Teeple Architects INC.

Reviewed
Reviewed as noted

Package 15 - Level 14 # Elevator Machine Room

PROJECT NAME: SQ ALEXANDRA PARK - BLOCK 11

DRAWING No.: ELR-1

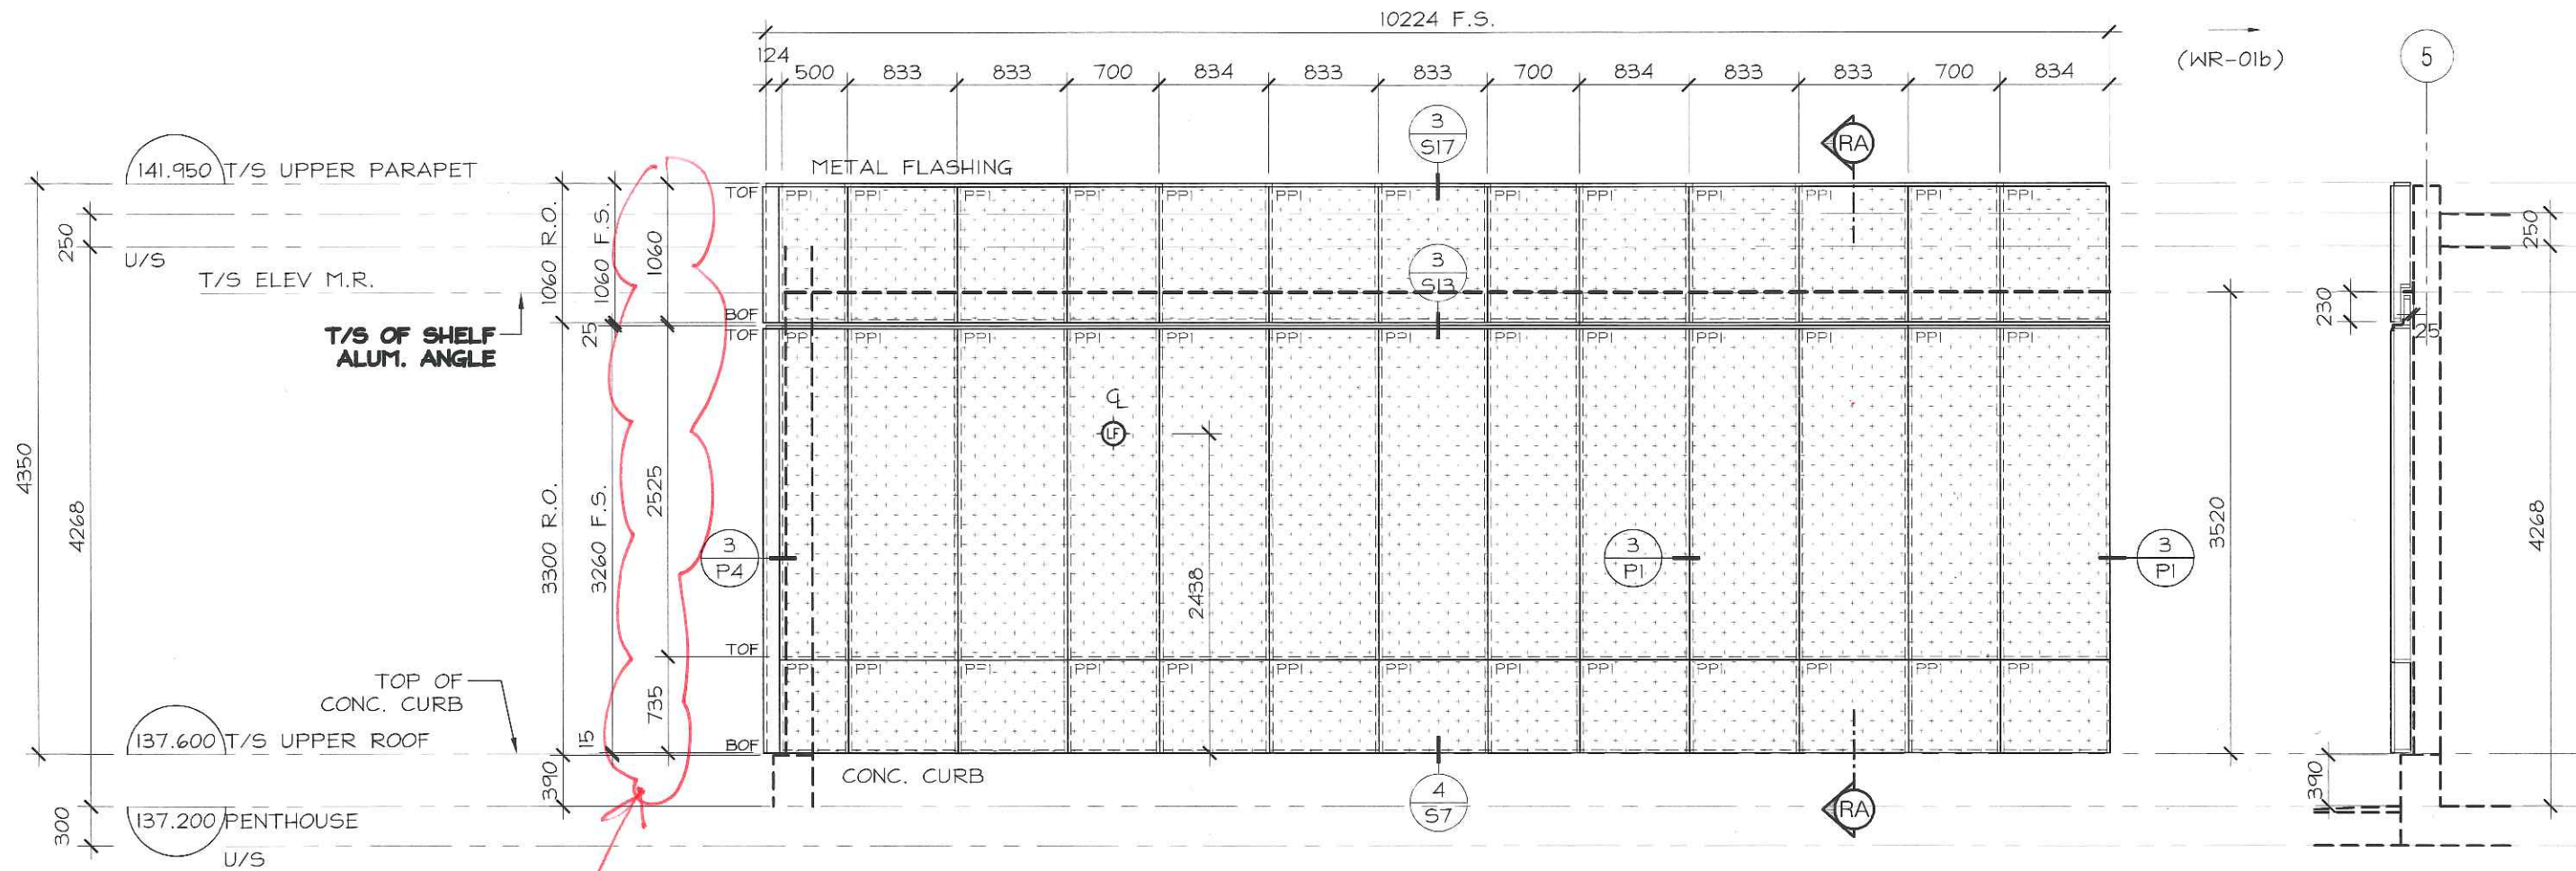
What is generating these dimensions?
